PROJECT MANUAL FOR: **Veterinary Science
Building Demolition**

PROJECT NUMBER: **CP233041**

2024-08-16

END OF ADDENDUM #2

Submission Date: 07/12/2024
Drawing Number: **C5.01**
Plot Date: 08/12/2024

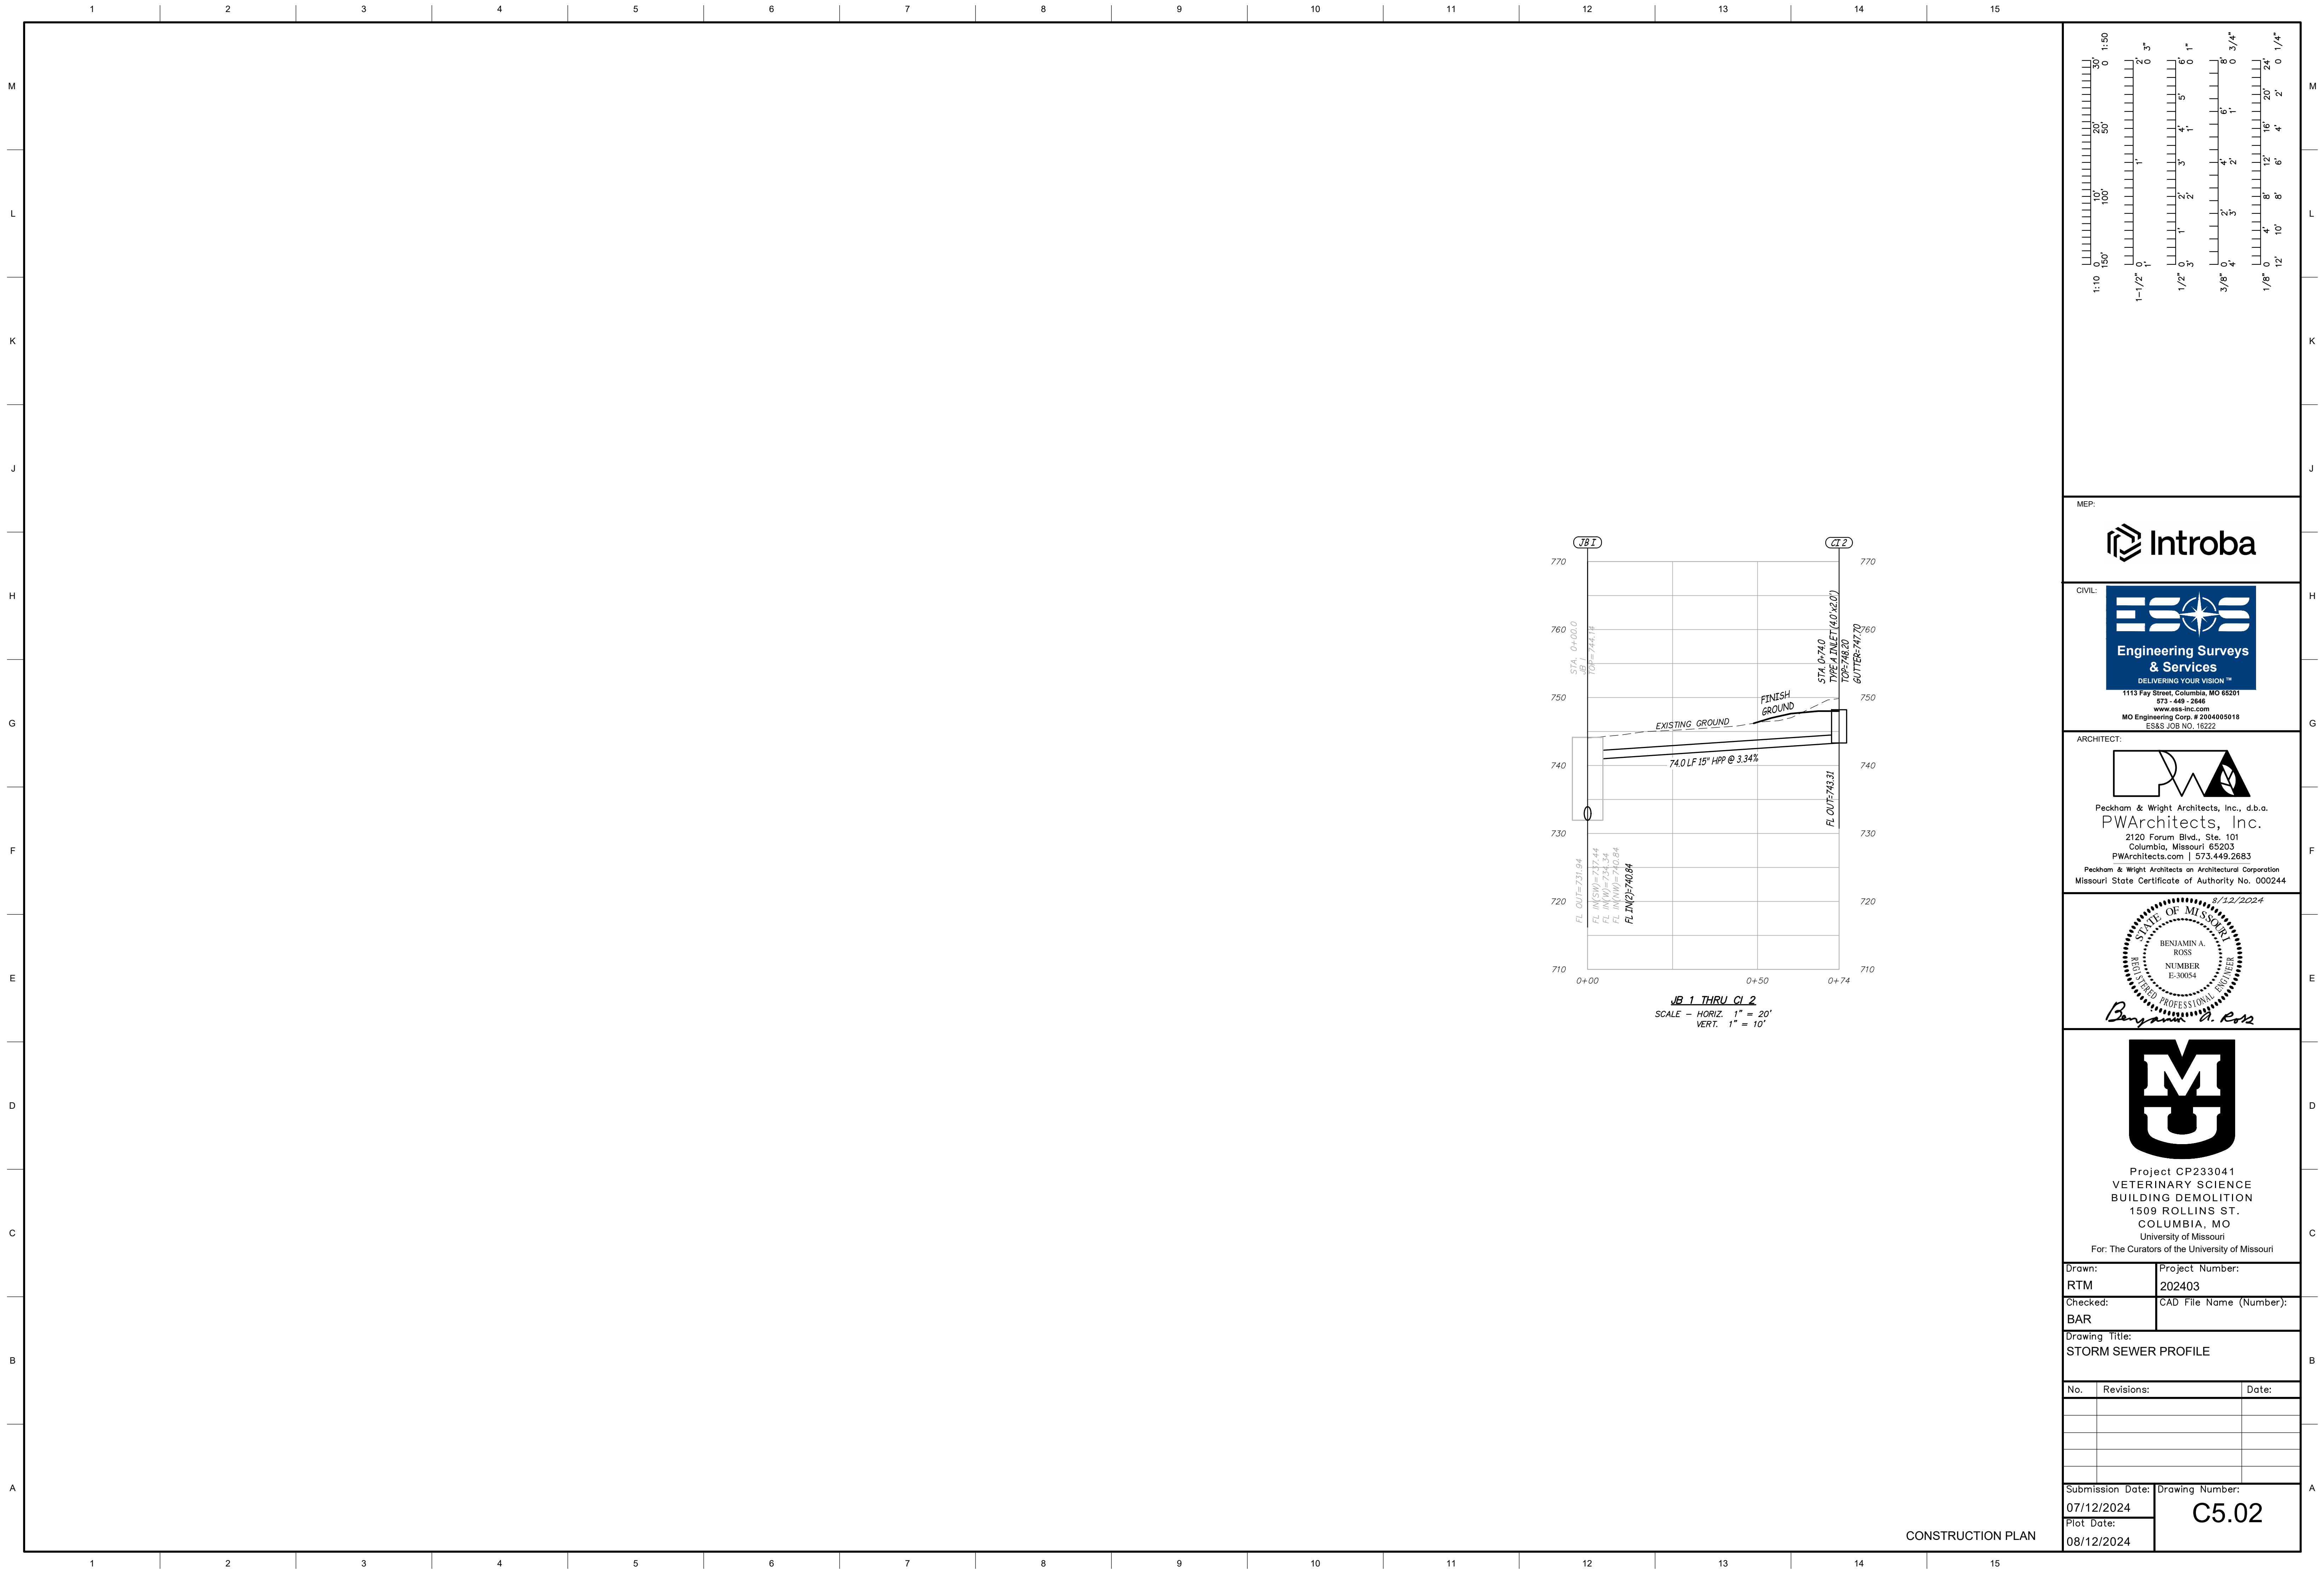
- G002 Location Map, List of Drawings, Codes:
 - ADD sheet C5.02 – Storm Sewer Profile to the Sheet Index.
- C0.01 General Notes:
 - ADD sheet C5.02 – Storm Sewer Profile to the Sheet Index.
- C5.01 Grading & Drainage Plan:
 - ADD notes at the storm sewer and inlet.
- C5.02 Storm Sewer Profile:
 - ADD entire sheet.
- C7.01 Site, Erosion Control, & Storm Sewer Details:
 - Add concrete sidewalk typical detail.
